**COMMISSION OF ARCHITECTURAL REVIEW
STAFF REPORT
February 27, 2018, Meeting**

13. **COA-029603-2018** (Obadiah LLC)

**512 West 19th Street
Springhill Old and Historic District**

Project Description: **Construct a new single family dwelling.**

1919 Sanborn Map

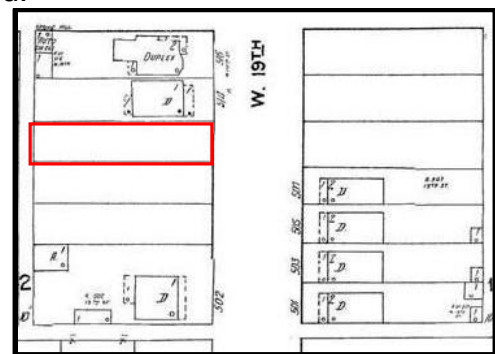
A context site plan was not provided. The historical pattern of the block is consistent with the setback pattern of the historic structures on the block as it appears much of the block including the subject lot was not developed.
